**STAFF REVIEW AND RECOMMENDATIONS  
PUBLIC HEARING  
FEBRUARY 26, 2020**

ABBREVIATED PLAT:       **STRINGFIELD**

REVIEWED BY:            **PEGGY HORTON**                                **CASE: 2020-016**

EXHIBIT D-1

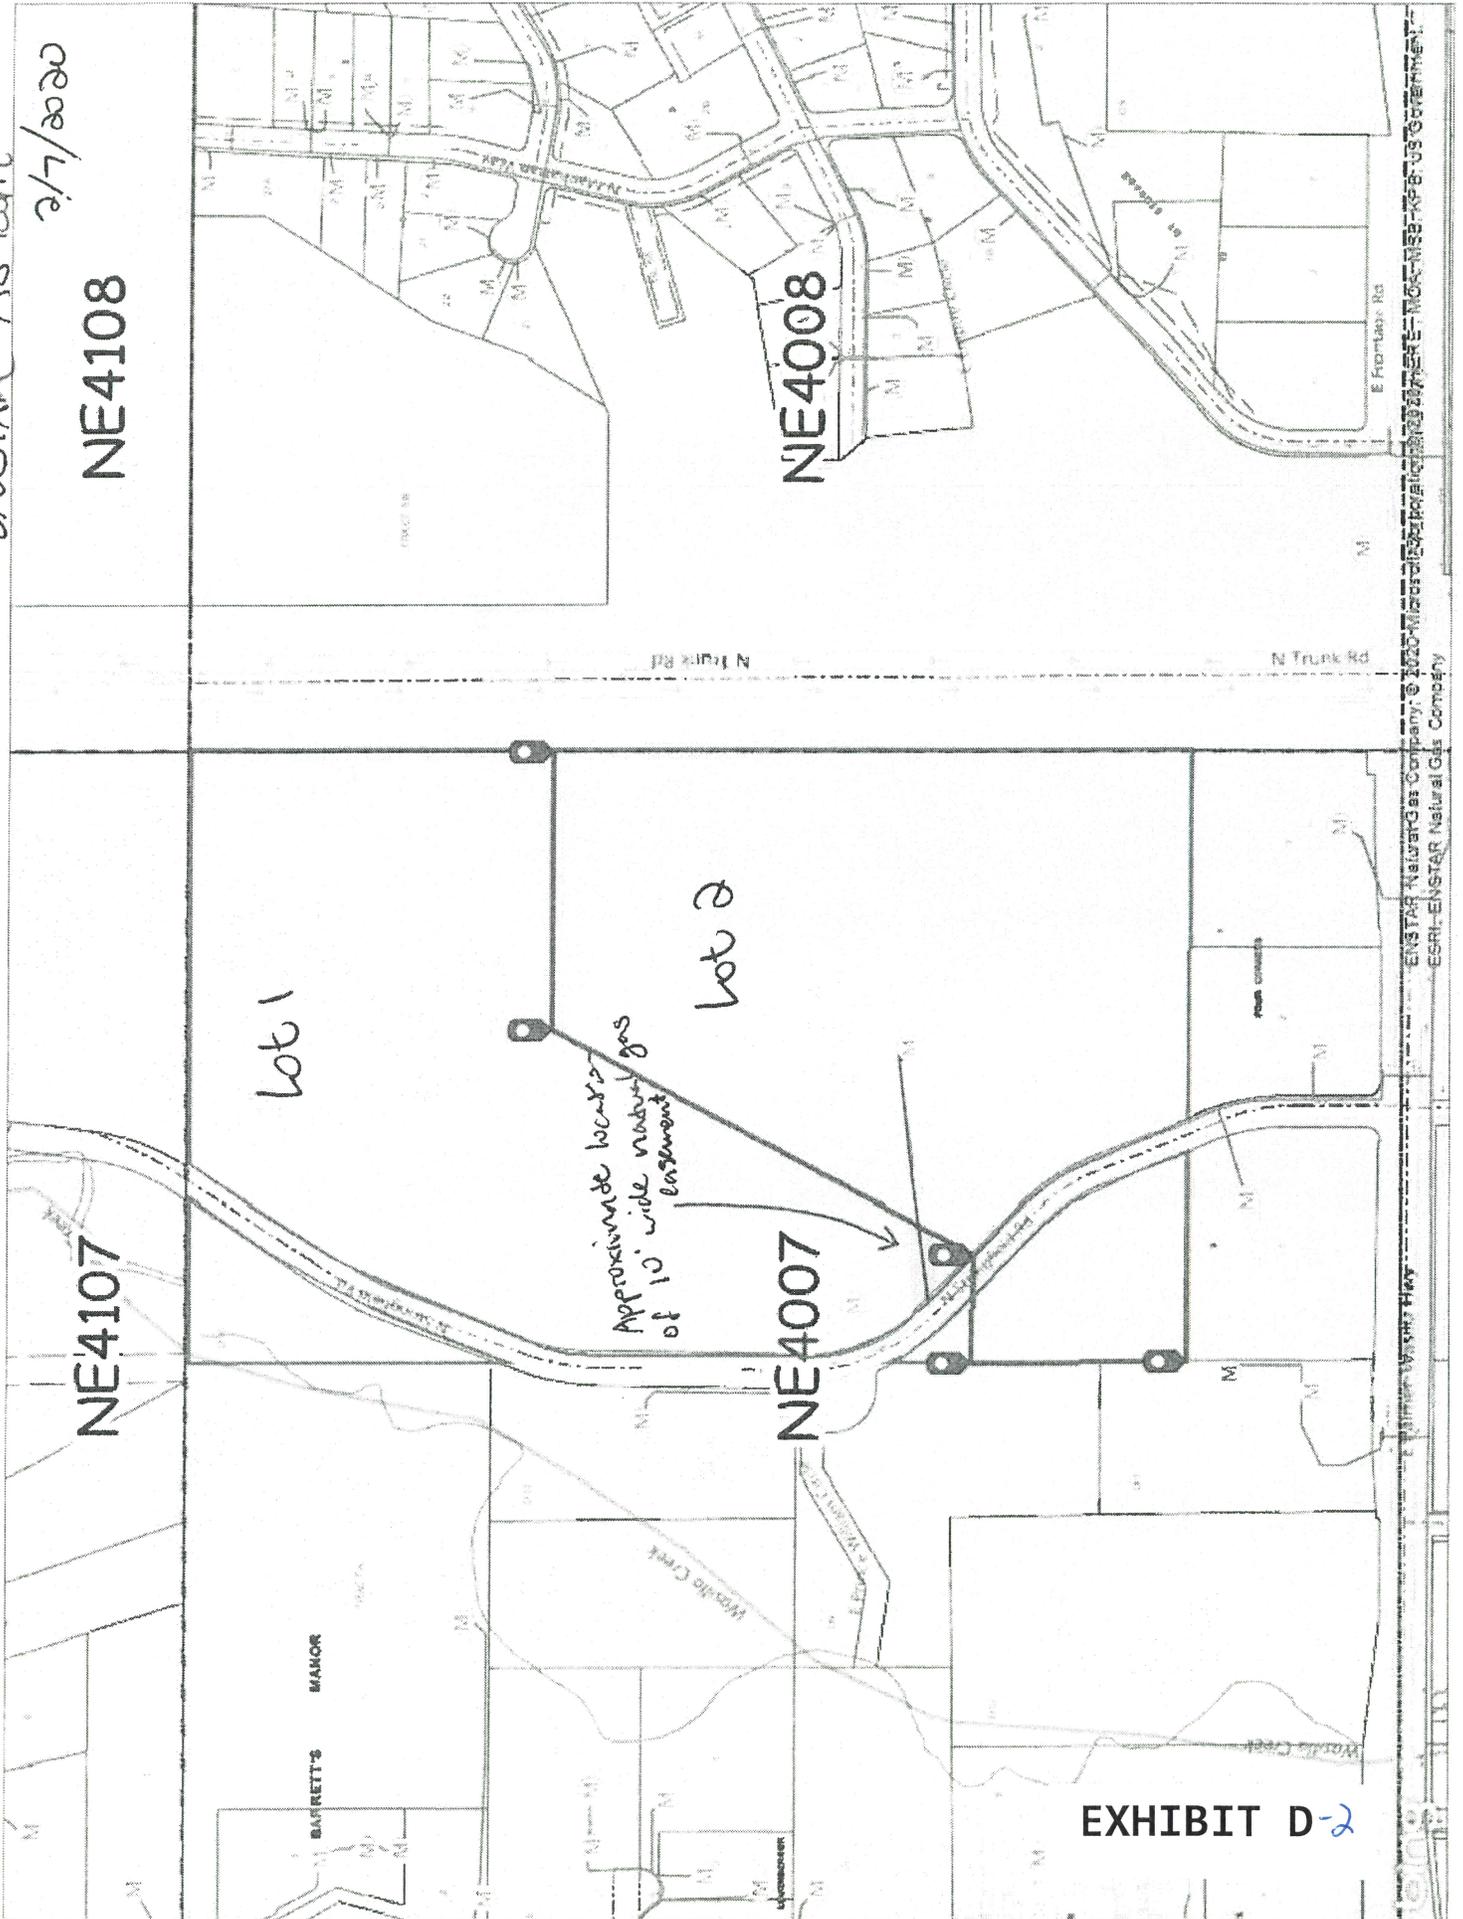
ENSTAR Natural Gas Company has reviewed **Stringfield (MSB Case # 2020-016)** and advises that there is an existing natural gas service line which appear to cross proposed Lot 1 to serve proposed Lot 2. Attached is an approximate ENSTAR as-built for your reference. ENSTAR objects to this plat unless one of the following scenarios is met:

1. Add a ten foot (10 FT) wide natural gas easement, centered on the existing natural gas service line as they cross Lot 1 to serve Lot 2.
2. Add a note which says, "There is a ten foot (10 FT) wide natural gas easement centered on the existing service line." And draw in the approximate location of the service line on the map and add, "Approximate location of natural gas service line and centerline of ten foot (10 FT) wide natural gas easement".
3. Owner signs an ENSTAR Natural Gas Easement document for a ten foot (10 FT) wide natural gas easement, centered on the service line at this location.

As Enstar gas line is existing from many years ago, the Borough will not be initiating a formal document for existing or future gas utility easement(s) until such time that development occurs on Lot 1. The Enstar comments will be placed in the file for future reference.
